78K0/Fx2 Microcontrollers Technical Notification (Technical limitation, Direction of use, Document modification, Specification addition)	Document No.	ZBG-BG-08-0003	1/1
	Data issued	July 3, 2008	
	Issued by	1st Body Solution Group Automotive Systems Division Microcomputer Operations Unit NEC Electronics Corporation 	
Related documents 78K0/FC2 User's Manual: U17555EJ4V0UD00 78K0/FE2 User's Manual: U17554EJ4V0UD00 78K0/FF2 User's Manual: U17553EJ4V0UD00	Notification classification	<input checked="" type="checkbox"/> Usage restriction <input type="checkbox"/> Upgrade <input checked="" type="checkbox"/> Document Modification <input checked="" type="checkbox"/> Other notification

1. Affected products

- All Products of 78K0/Fx2 microcontroller
 - 78K0/FC2: μ PD78F0881, μ PD78F0882, μ PD78F0883, μ PD78F0884, μ PD78F0885, μ PD78F0886
 - 78K0/FE2: μ PD78F0887, μ PD78F0888, μ PD78F0889, μ PD78F0890
 - 78K0/FF2: μ PD78F0891, μ PD78F0892, μ PD78F0893

Figure 1. Example of phenomenon which occurs when LVION flag is cleared to "0"

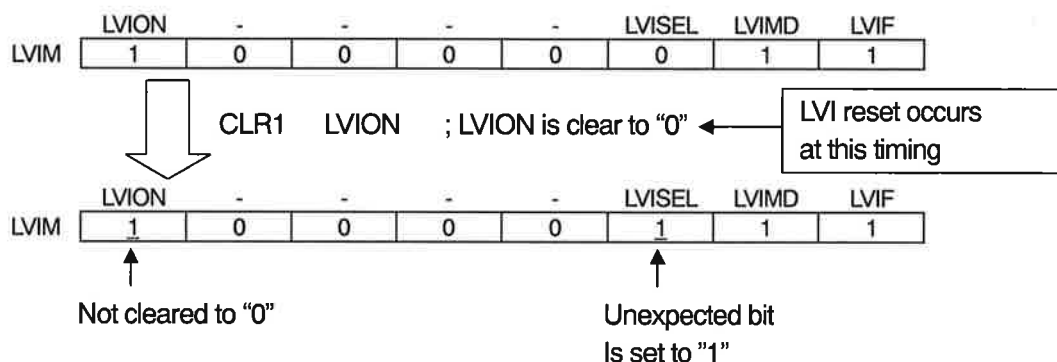
If LVI reset occurs at the same timing of write timing for LVI registers (LVIS/LVIM), the value of SFR-bit of these registers might become "1". As a result, the following two phenomenon are occurred.

- LVI will be not stopped.
- Low voltage detect pin will be changed to "EXLVI" pin.
- LVI detect voltage will be changed to the lower level than the level which is set by LVIS.

Figure 1 shows the example in case this phenomenon occurs at the timing that LVION flag is operated.

1. In case LVI is used as RESET, please do not write LVIM/LVIS register after once these registers is set.
2. Before setting of LVIM/LVIS register, please confirm that bit-7 of LVIM register (LVION) is "0". If LVION is "1", do not execute the write instruction for LVIM/LVIS. By this workaround, LVIM/LVIS will be set when external reset or POC reset or Watchdog timer reset is occurred, and not be set when LVI reset is occurred.

Fig. 4-1 Operation of internal high-speed oscillator after initial starting or after exit from STOP mode

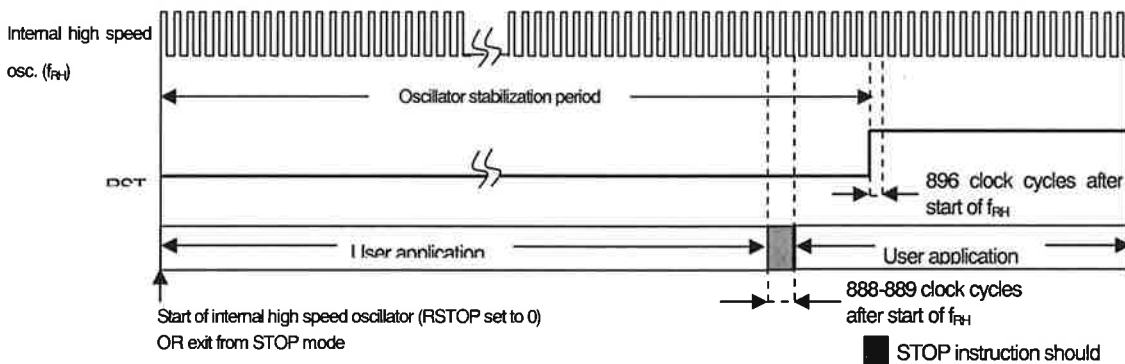
If the microcontroller is using the internal high-speed oscillator (f_{RH}) as the CPU clock, then when a STOP instruction is executed, under certain circumstances the device will enter a state of undefined operation and it will not exit from STOP mode by interrupt. There are certain timing conditions between the execution of the STOP instruction and the internal high speed oscillator which cause this situation and they are listed below.

- The instruction is executed 888-889 clock cycles after the internal high speed oscillator is enabled (RSTOP set to 0).
- The instruction is executed 888-889 clock cycles after the device exits from STOP mode, and the CPU was operating from the high speed internal oscillator prior to entering STOP mode and continues to operate from the same clock source when it exits STOP mode.
- The instruction is executed 408-701 clock cycles after the device finishes initializing after a non-POC (power up) Reset; i.e. WDT, LVI, external reset.

- 1) Postpone the execution of the STOP instruction until a check is performed on the RSTS bit and it is verified that it is 1.
- 2) A delay is implemented in the software such that it can be insured that the STOP instruction will not be executed until after the previously mentioned conditions have passed.

Fig. 4-2 Reset due to factors other than POC

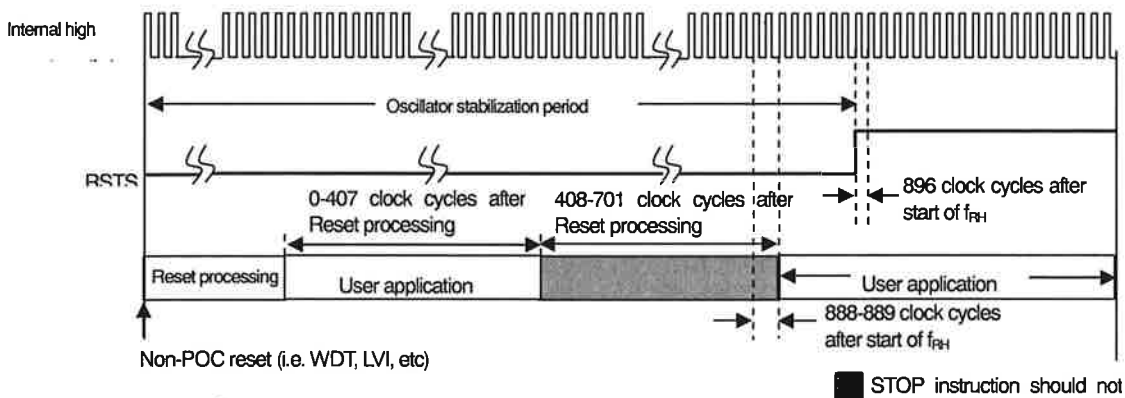
When one of the described situations occur s, the device abnormally enters into STOP mode. As a result, the following conditions occur-

- The device will not exit STOP mode when an interrupt occurs
- The internal high speed oscillator does not stop. Hence the current consumption is greater than what is specified for STOP mode; approximately 150-400 uA.

Figure 5-1 Methods of entering flash memory programming mode

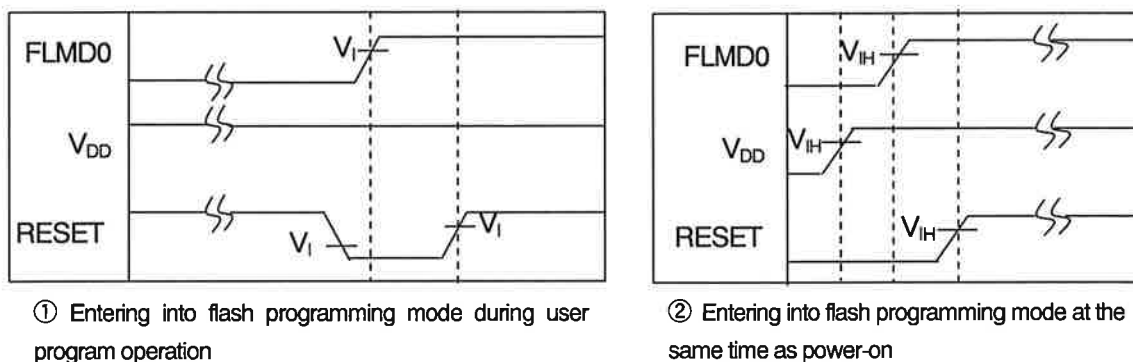
- When the Run After Disconnect function is used during programming with the flash memory programmer (PG-FP5) or MINICUBE2.
- When the programming environment has been configured based on the Application Note (Programmer) (U17739EJ2V0AN00) and when leading the user program operation to the flash memory programming mode (Figure 5-1 (1))

If the duration of the reset signal applied to the external RESET pin is shorter than 1,950 ms when entering the flash programming mode during user program operation without dropping the power supply voltage to the level of the POC detection voltage ($V_{POC} = 1.59 \text{ V} \pm 0.15 \text{ V}$), the following phenomenon may occur.

- A POC reset occurs upon reset release and the flash memory programming mode is not entered normally. Consequently, the user program is executed without performing programming processing.

Secure a reset period for 1,950 ms or longer by controlling the external RESET pin when leading the flash memory programming mode.
